ADDENDUM NO. 3

SCC Mohr Hall Replacement

LRCCD BID NO. 18025

LRCCD Sacramento City College Mohr Hall Replacement Building
 Los Rios Community College District
 LRCCD Bid No: 18025

**REVISED RAINWATER LEADER
 LOCATION AND BRAKE SHAPES**

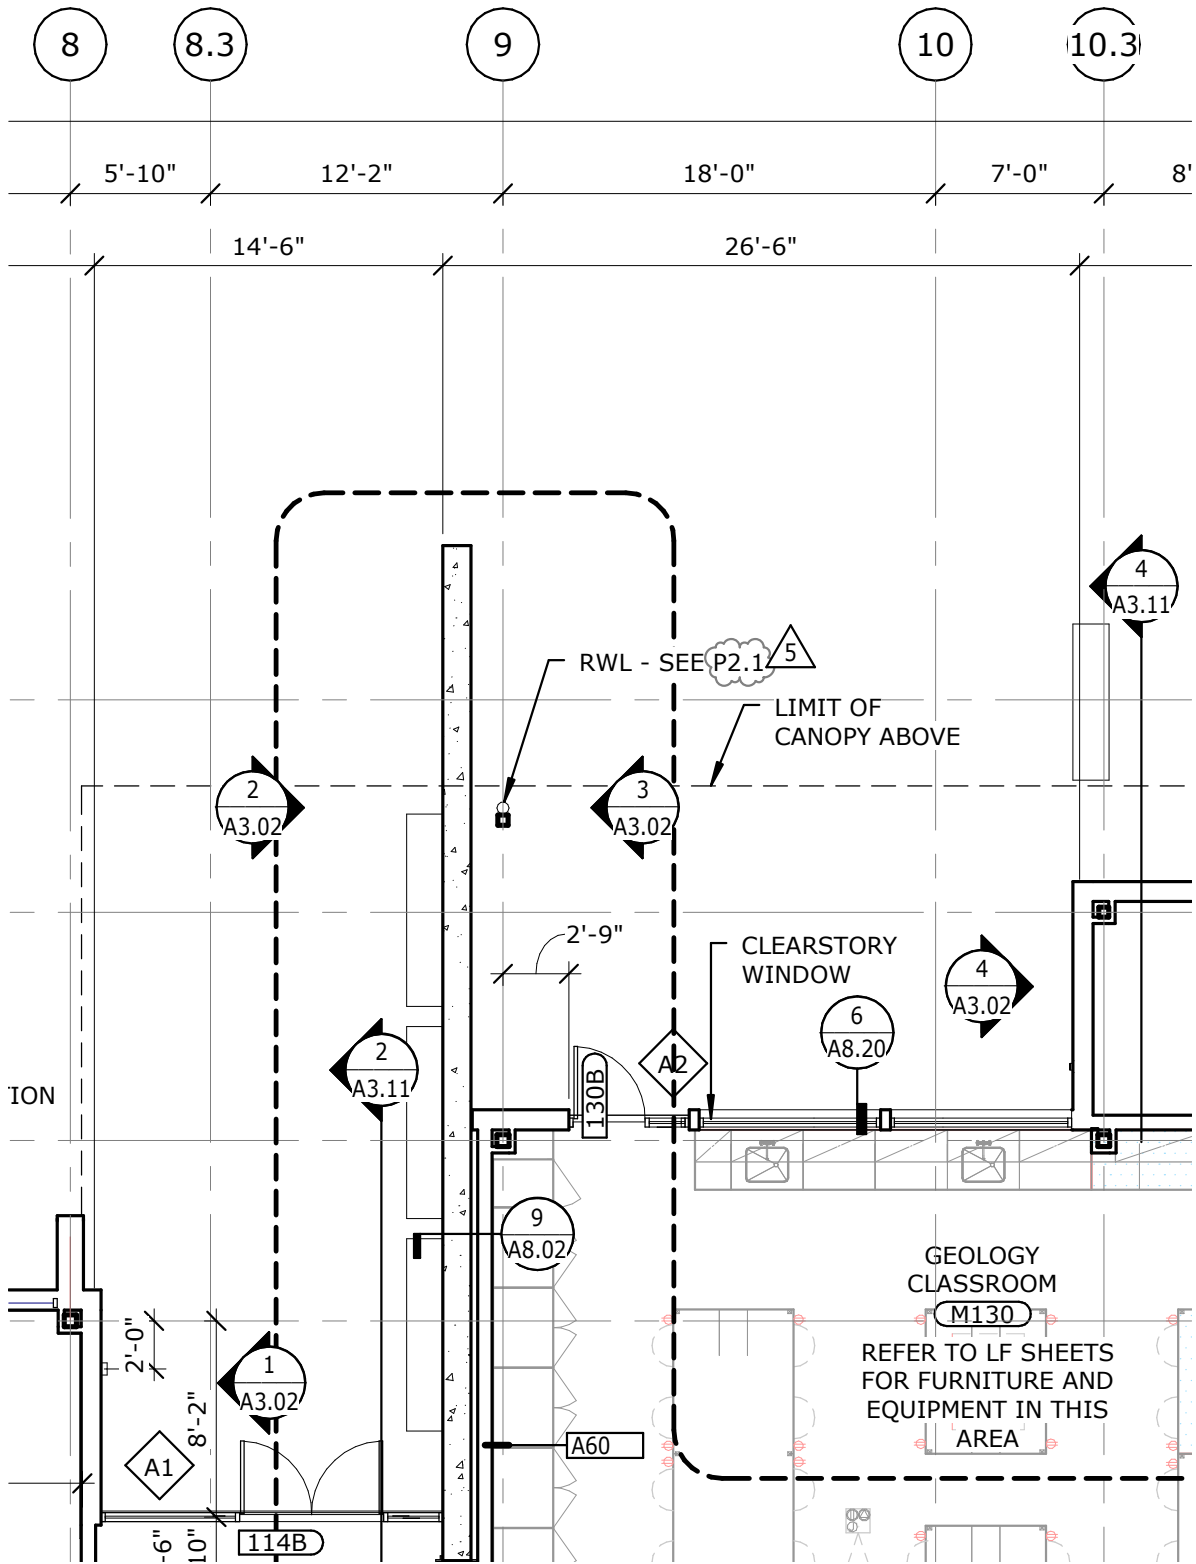
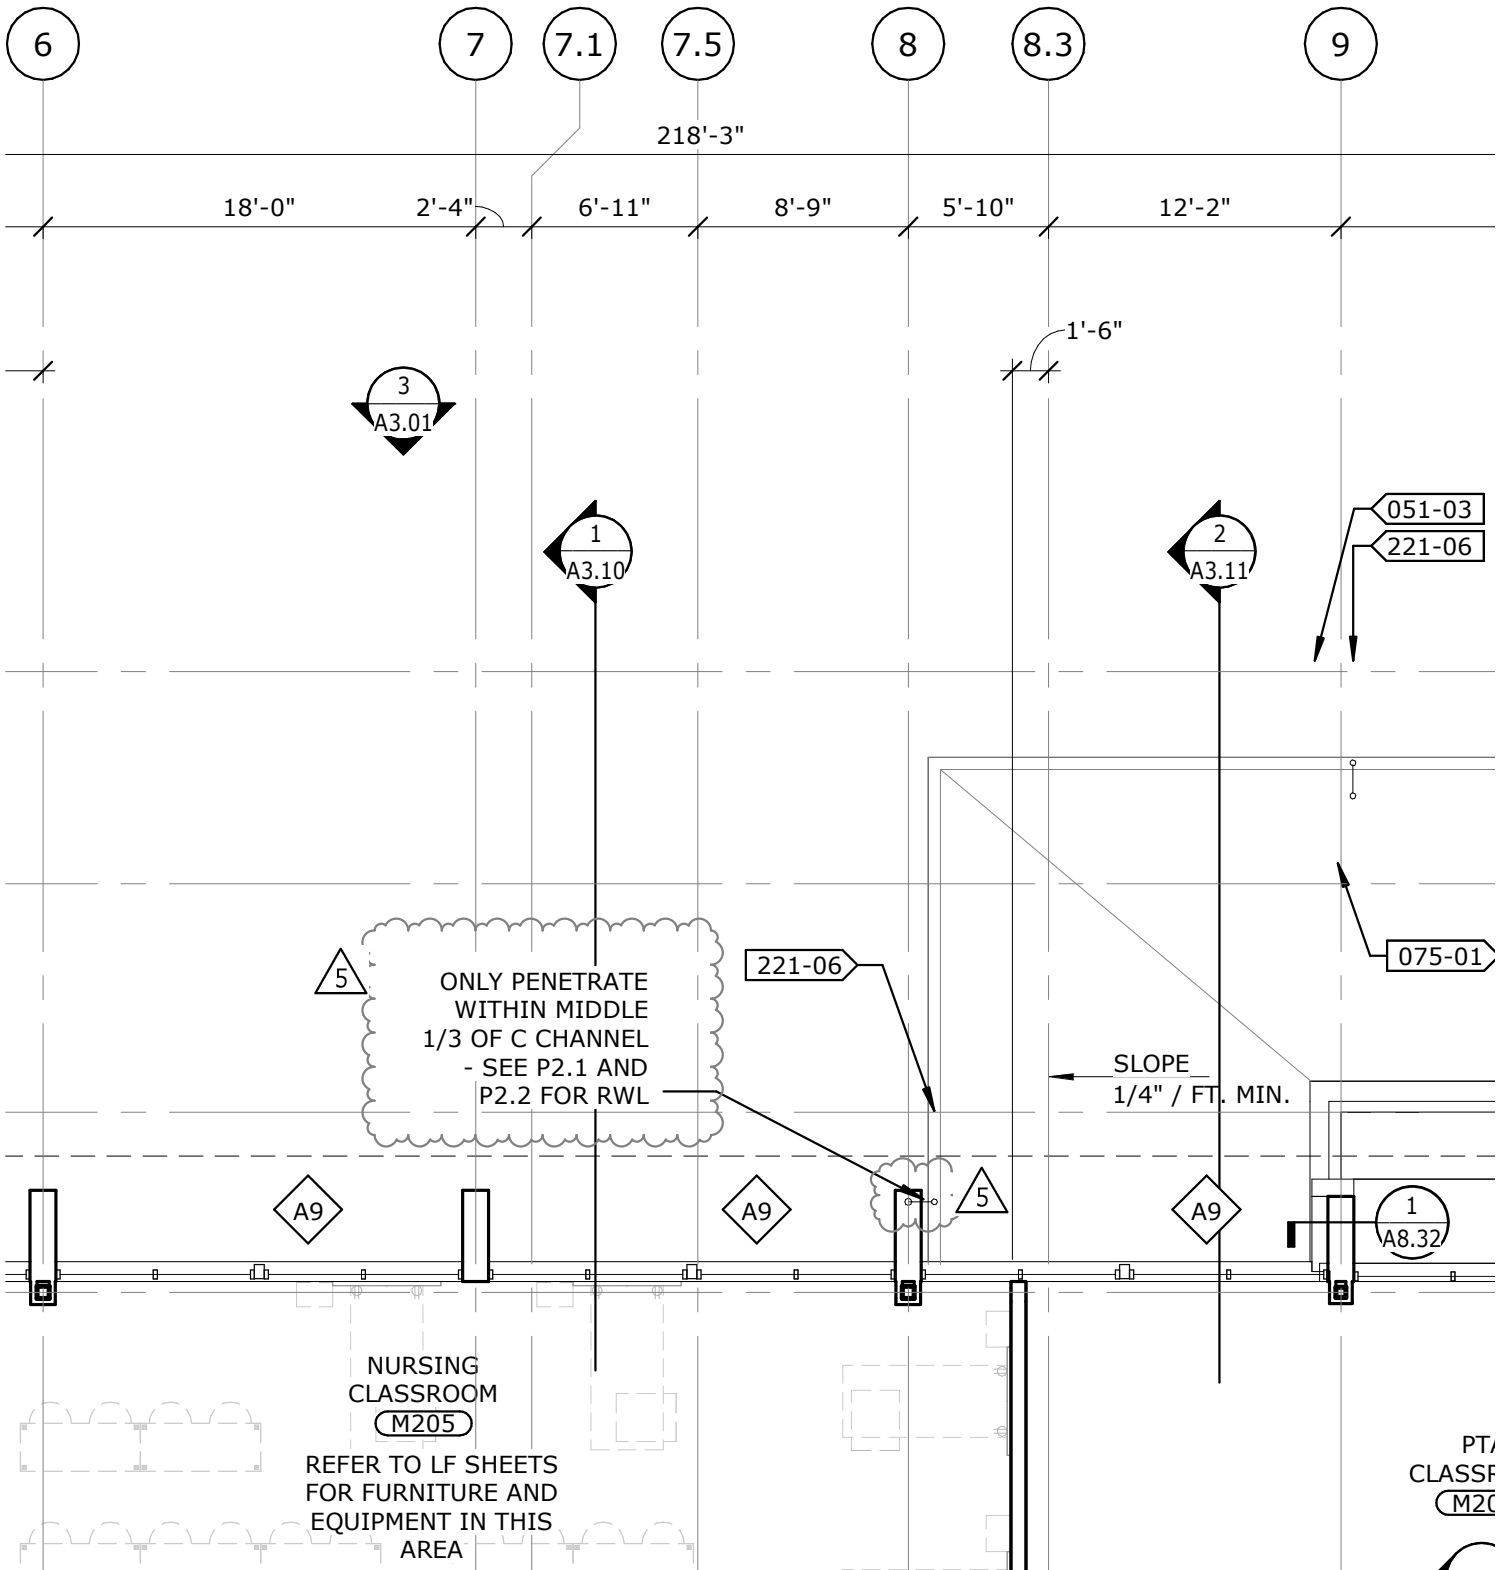
1.1		RFI responses
1.2		DSA Form 143 for Addendum 3
2		Existing Lillard Hall drawing provided to bidders. In response to bidding RFI
3		IAPMO UES Evaluation Report 510 and 444. Reference material for detail callouts 2/A8.30, 1/A8.31, 2/A8.31
4	C6.0	New POC for new rainwater leader and revised POC for existing RWL lines. Remove and replace sheet
5	A2.01	Rainwater leader added to column near gridlines D and 1. Brake shape added to column near gridlines D and 1 and at column near gridlines E and 1.
6	A2.01	Note revised at Rainwater leader at entry canopy to reference P2.1
7	A2.02	Note added to rain water leader near gridlines 8 and A.8

VCT FLOORING PRODUCT
DISCONTINUED - MNFR. REVISED

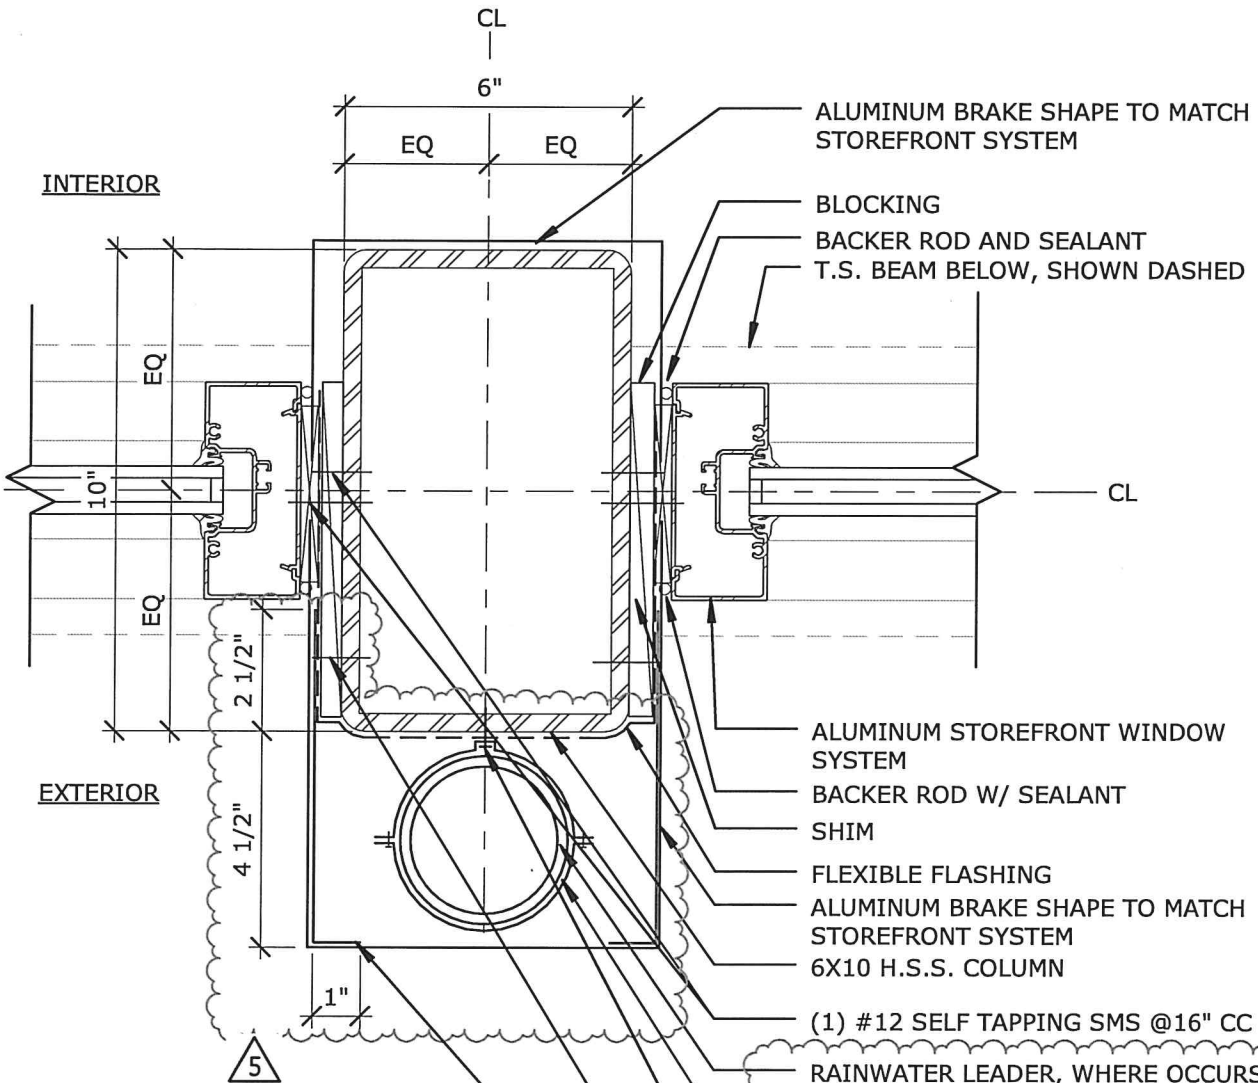
Question: I have discovered that the flooring spec'd for the SACRAMENTO CITY COLLEGE Mohr Hall Replacement project has been discontinued. 97% of the flooring for this project, approximately 20,000 sq.ft, was to be Vinyl Composite Tile made by Mannington Commercial. Mannington stopped making V.C.T tile about 4 years ago. They do not have any left over. Do you know if a replacement product has been selected?

Answer: VCT flooring product discontinued - Manufacturer revised. See revision to sheet A2.53

EXTERIOR STOREFRONT JAMB -
 STEEL COLUMN
 3" = 1'-0" REFERENCE: A2.50 / 6

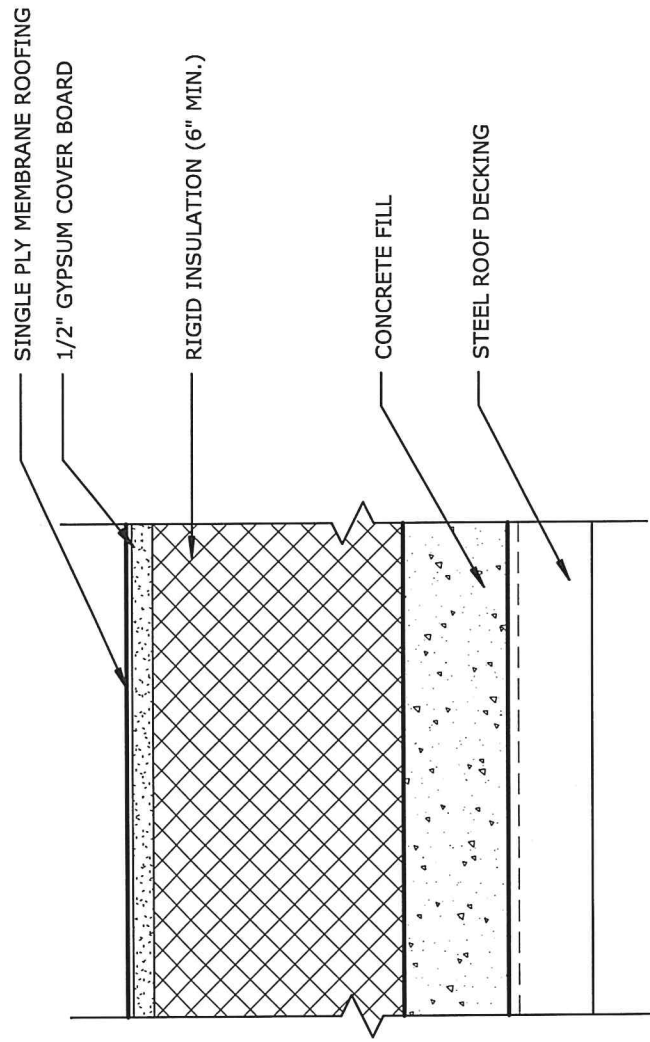
8	A2.50	One detail reference added / revised at window jambs A21b middle, A22b middle, A23b middle
9	A2.53	VCT flooring product discontinued - Manufacturer revised
10	A8.21	Dtl.12 -Exterior Storefront jamb - at steel column - revised DTL., rainwater leader added. Detail is pending review with DSA, no revisions are expected.
11	A8.30	Dtl.2 - roof type C revised. Detail is pending review with DSA, no revisions are expected. Detail is pending review with DSA, no revisions are expected.
12	A8.31	Dtl.1 - Fascia mansard gutter revised. Detail is pending review with DSA, no revisions are expected.
13	A8.31	Dtl.2 - revised. Detail is pending review with DSA, no revisions are expected.
14	A8.31	Dtl.7 – revised. Detail is pending review with DSA, no revisions are expected.
15	A8.31	Dtl.14 - Revised - (not used). Detail is pending review with DSA, no revisions are expected.
16	1/M1.1	Note added to clarify conduit running from equipment yard to building. Response to bidding RFI

REF SHEET: 2/A8.30
6/22/18
B5017.00

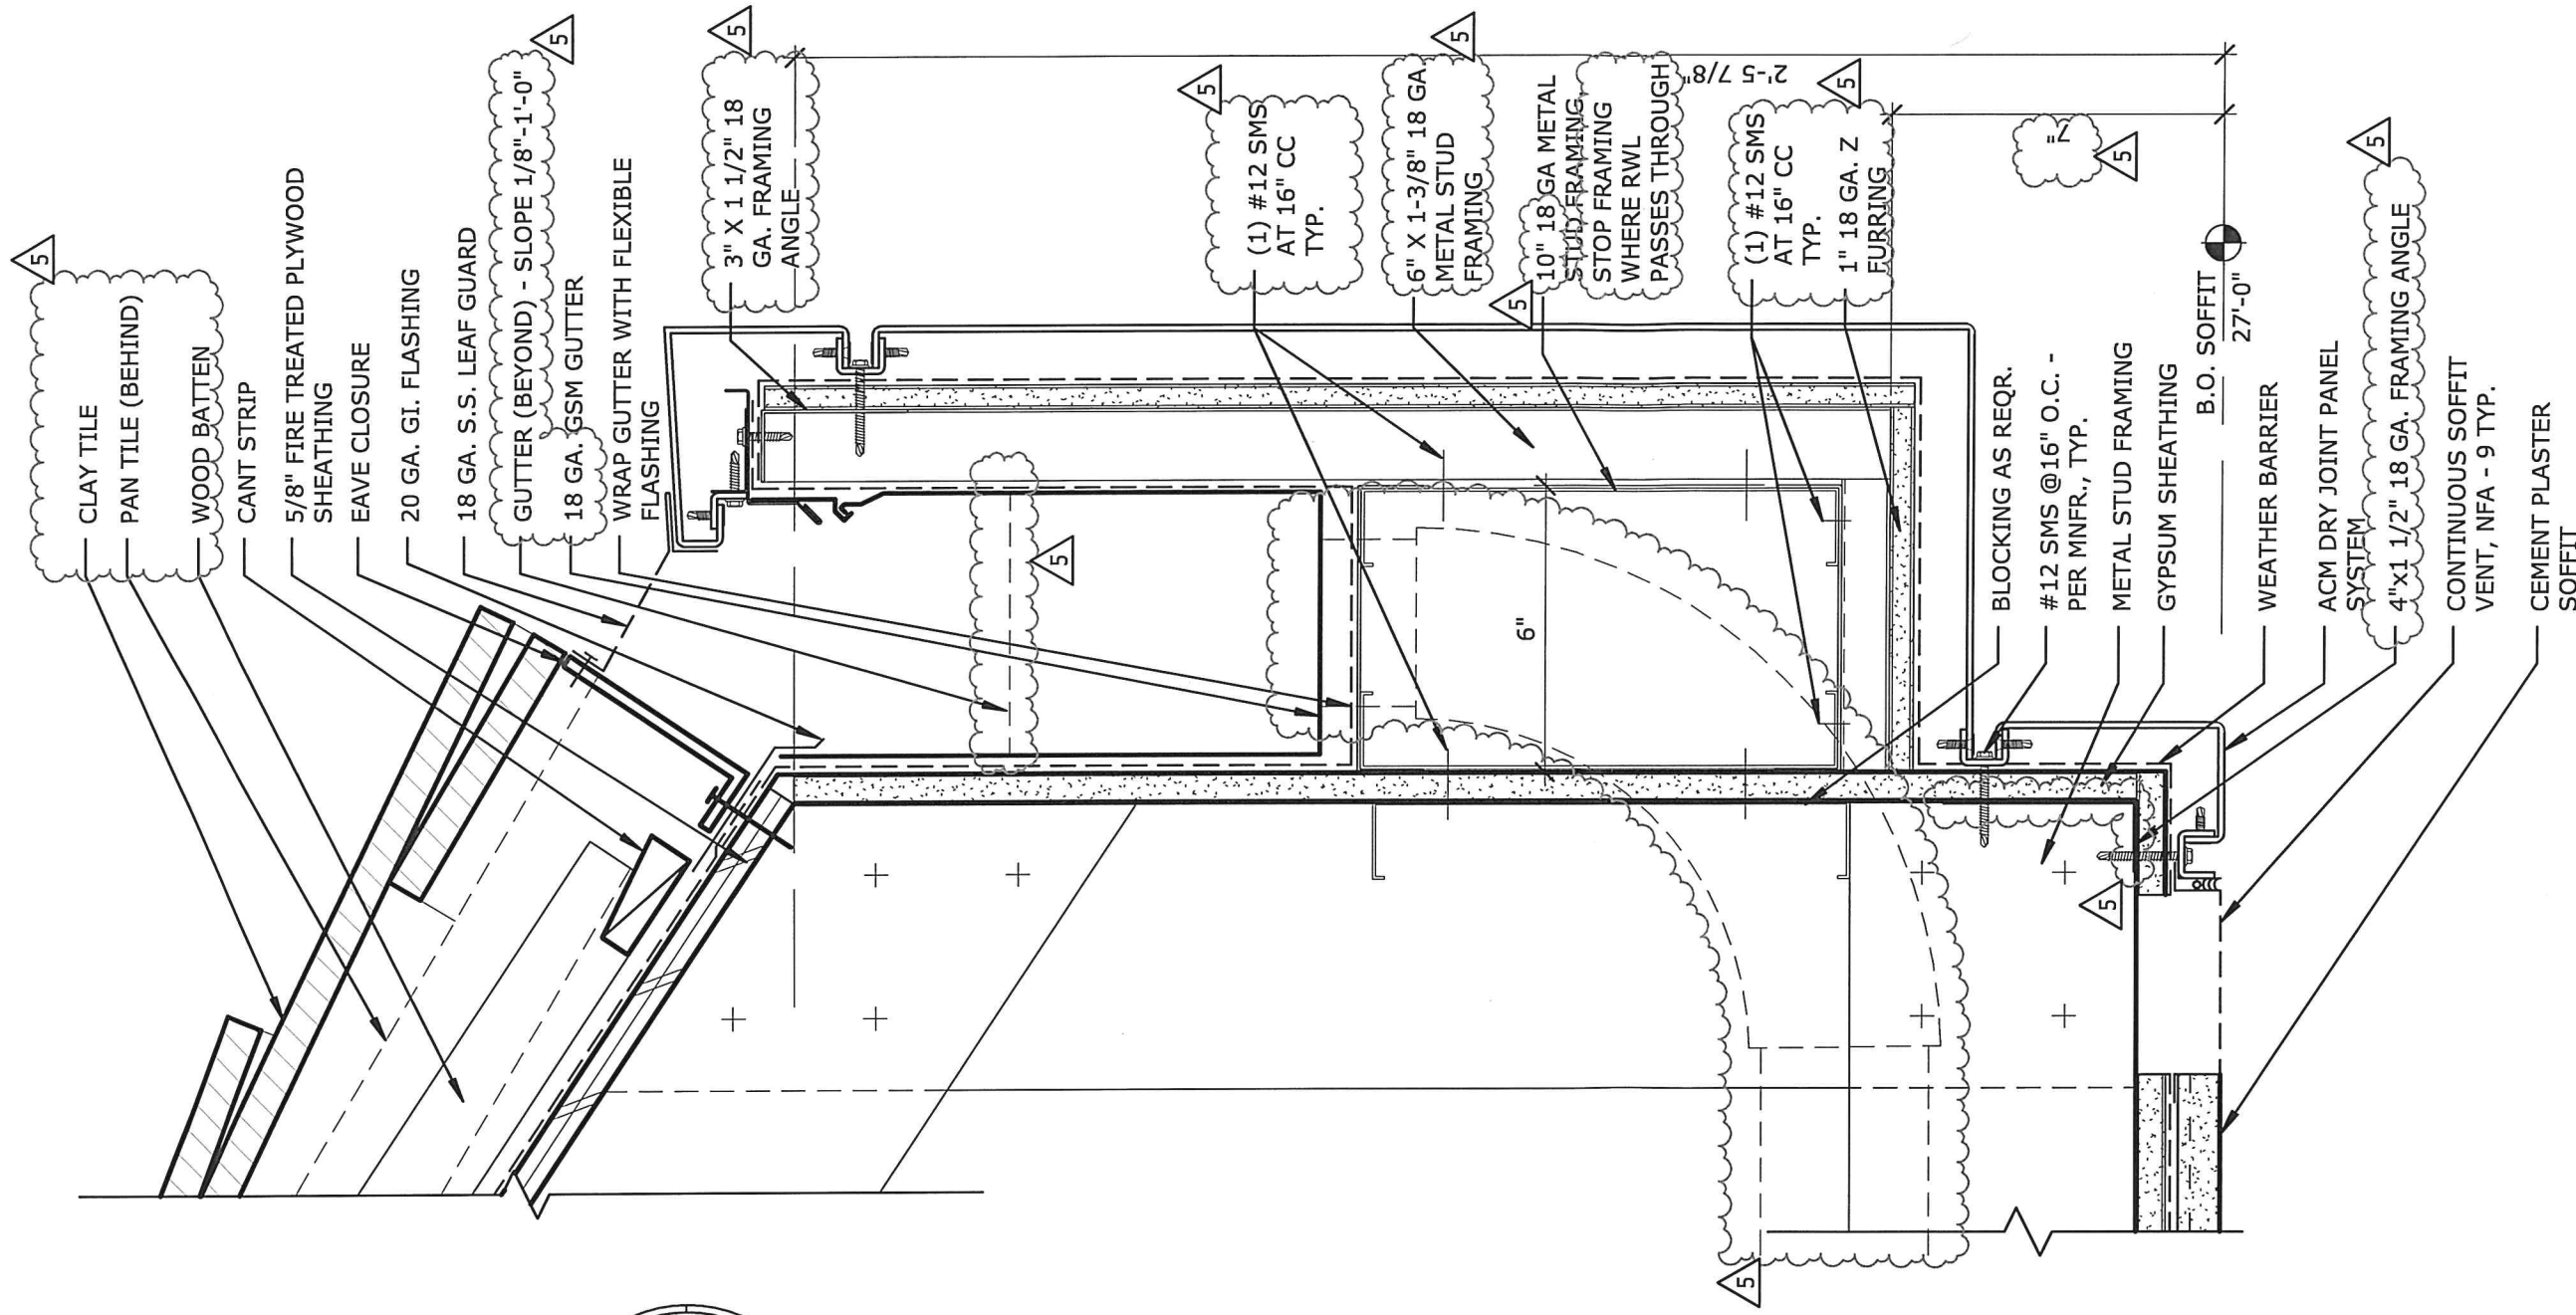
Question: The specs the details and the sheet notes for the tile roofing are all different, one calls out SS Tye wire system, the detail show a vertical wood nailer under each tile and the spec calls out a batten system. I would think the SS Tye Wire system would make more sense.

Answer: See revised details 2/A8.30; 1,2,14/A8.31 and spec section 07 32 13. Wood batten system should be used.

NOTES:
1. ALL ROOF TILES TO INCLUDE —
— STAINLESS-STEEL TIE WIRE —
— FASTENING —
2. TILE ROOFING TO COMPLY WITH
IAPMO UES 510, IR 15-1, IR15-2
3. SEE 14 FOR CLAY TILE —
— DETAILS A8.31 —
4. PROVIDE APPROVED WIND LOCK AT
EACH TILE, COMPLY WITH IAPMO UES
444.
